MODIFICATION REPORT

**Affordable Housing Development
6 Halifax St Macquarie Park
SSD-65931214 (MOD 3)**

Lot 117, DP 1224238, 6 Halifax Street, Macquarie Park
SSD-65931214 (MOD 3)

Figure 5 Example internal changes to the Level 2 floor plan

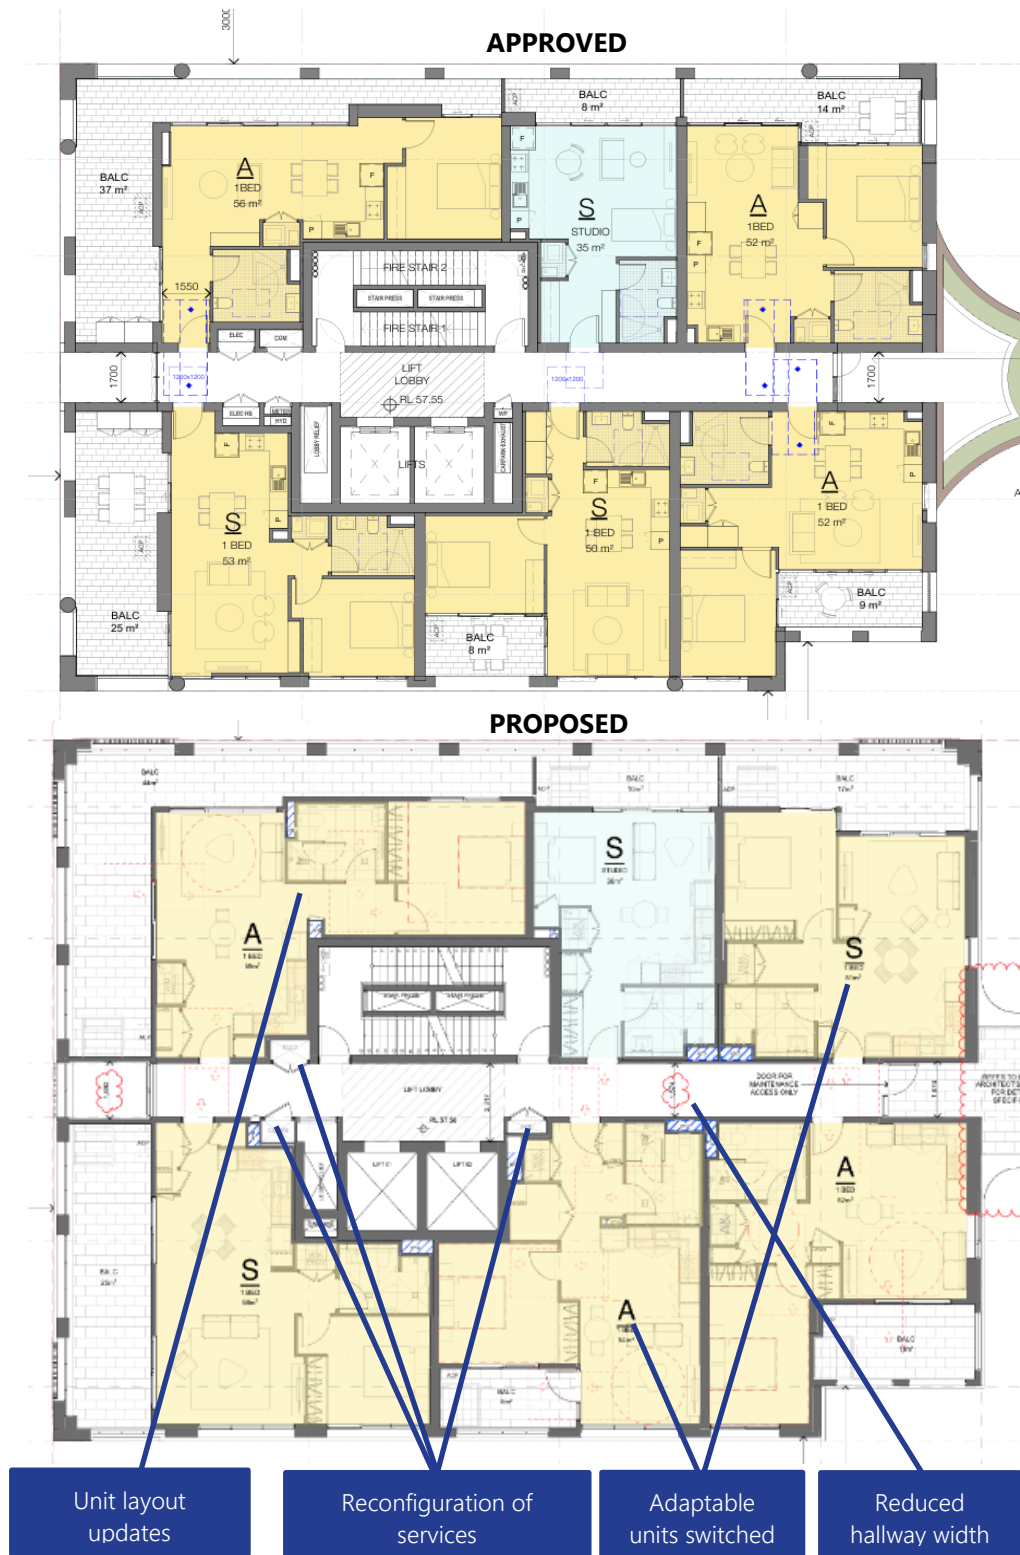
Each floor has minor internal adjustments in response to the reduced building footprint, finalisation of the servicing design, optimisation of unit layouts and reassigning adaptable units to larger units on levels 1 and 2.

The internal changes remain consistent with the ADG in relation to the size of apartments, floor to ceiling heights and storage with no significant impacts resulting from the internal layout amendments. Examples of the proposed changes have been illustrated within **Figure 5** to **Figure 8**.

Figure 8 Example changes to roof top plan

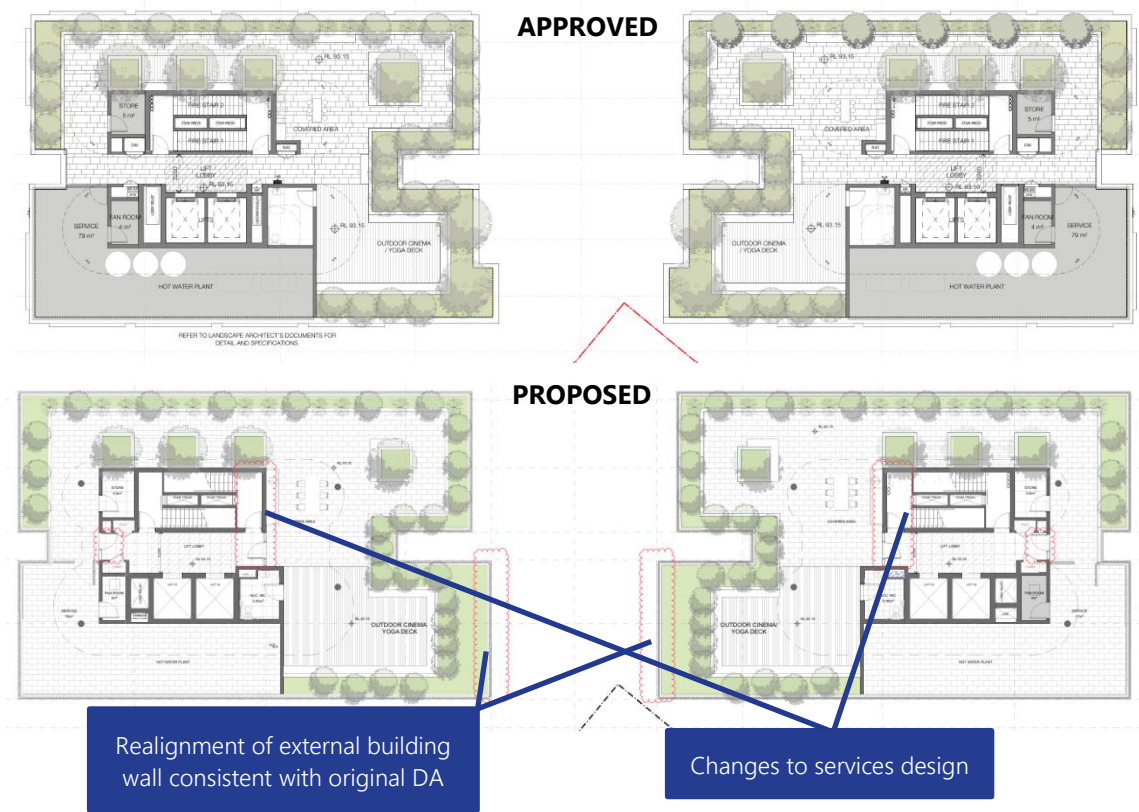
- Modified plant room screening layout on the roof level in response to the servicing updates to this level. This change does not impact the overall building height but rather responds to the layout of the updated roof design.

The roof level layout has been adjusted to reconfigure the storage rooms and servicing layout. This triggers changes to the screening layout around this area to align with these changes. No increase in building height is proposed under this modification – refer to **Figure 4**.

Figure 9 Internal facing bedroom windows

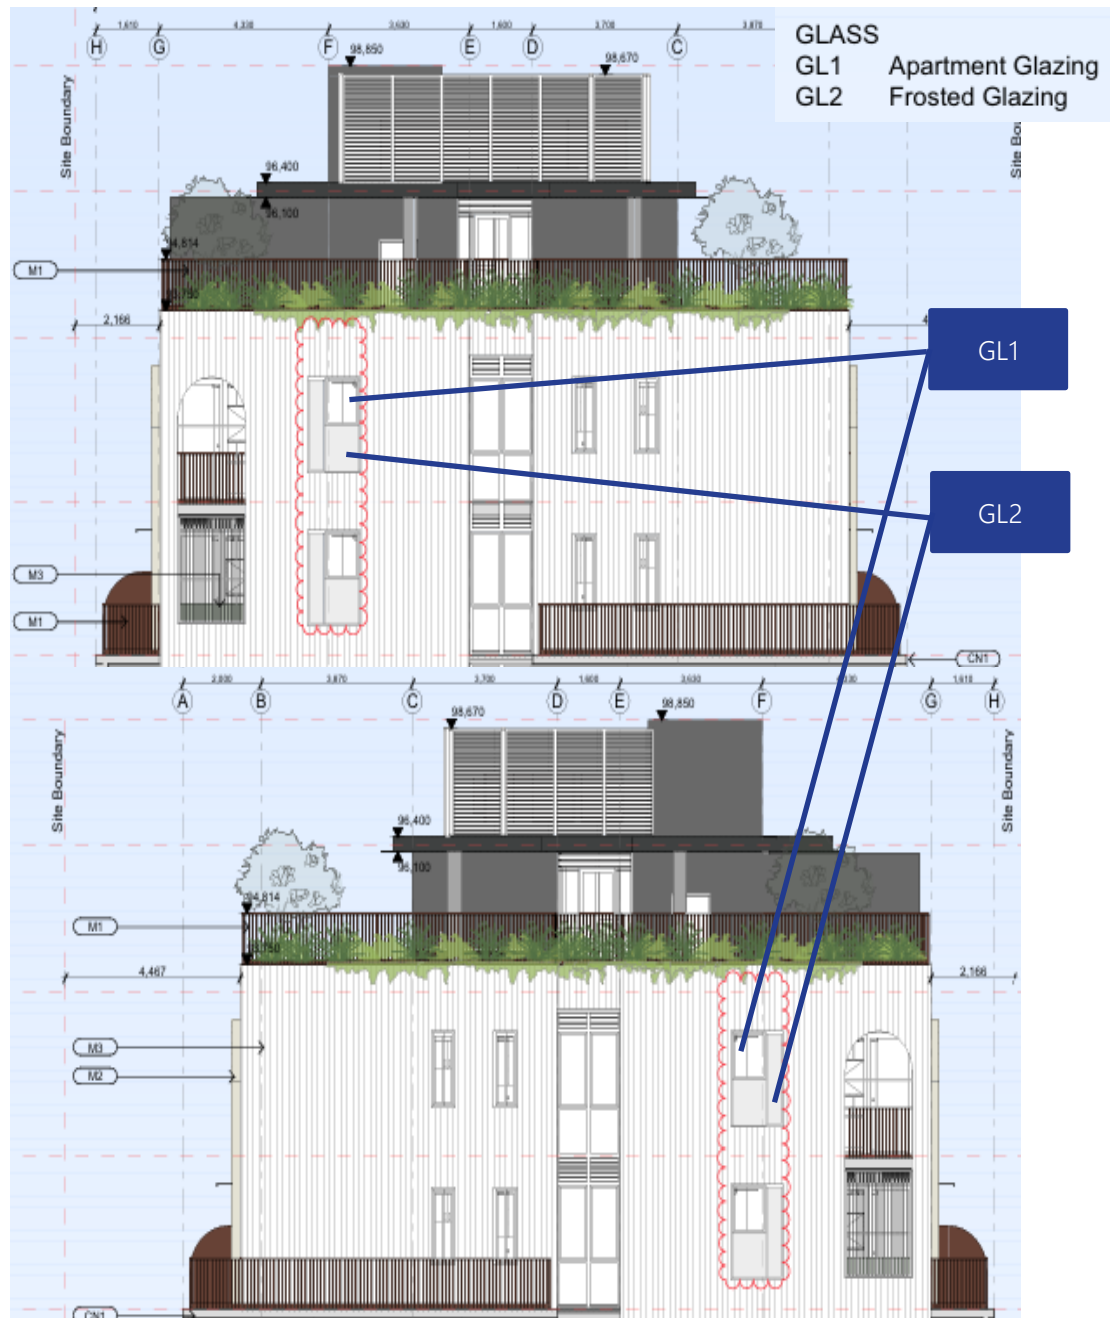
In general, there are not considered to be any adverse impacts resulting from the external changes. The only likely significant impact as a result of the external building amendments relates to privacy impacts between the reintroduced central facing bedroom windows on Level 11 and 12. To address privacy, these windows are proposed to comprise primarily of frosted glazing to obscure direct views up to a sill height of 1.6m as illustrated within **Figure 9**. Blinds will also act to provide optional additional privacy to residents, as needed.

The design solution to address privacy remains consistent with the windows below Level 11 and 12 and the original condition of consent (now deleted B2(a)) which permitted fixed obscure glazing to address privacy impacts between central facing windows.
